SITE PLAN

E01	FF-M5	D/F ILLUM. MONUMENT SIGN

PRSG20251417

CLIENT: Fairfield BY MARRIOTT

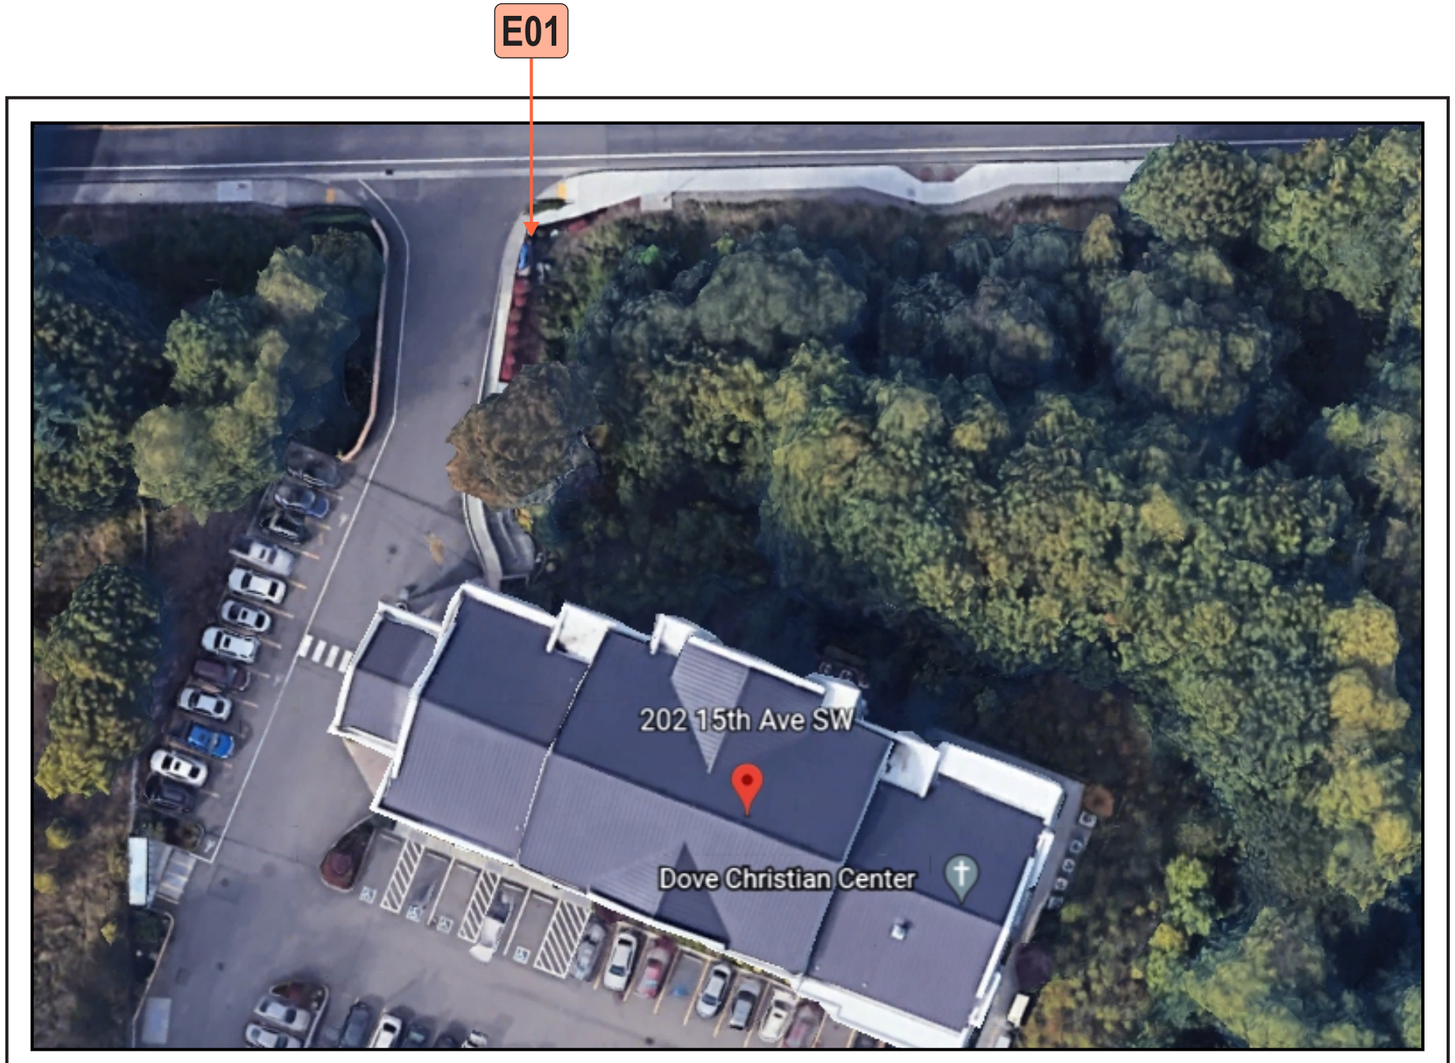
Per PMC 20.60.075(1), Nonconforming signs:
(1) In the event a nonconforming sign is removed, replaced, or structurally altered, pursuant to installation of a new sign, all applicable sections of the Puyallup sign ordinance shall apply to the new proposal. The alteration or enlargement of existing signs shall not increase the degree of nonconformity, in terms of number, size, height, setback or any other applicable regulation.

Per approval by the DPS Director, the proposal to reduce the square footage of the monument sign from 21 sq. ft. to 20.5 sq. ft. will not increase its degree in nonconformity.

No obstruction to the public right-of-way permitted. All work shall take place on private property. No ground disturbance permitted since the existing base is to be reused for proposed sign.
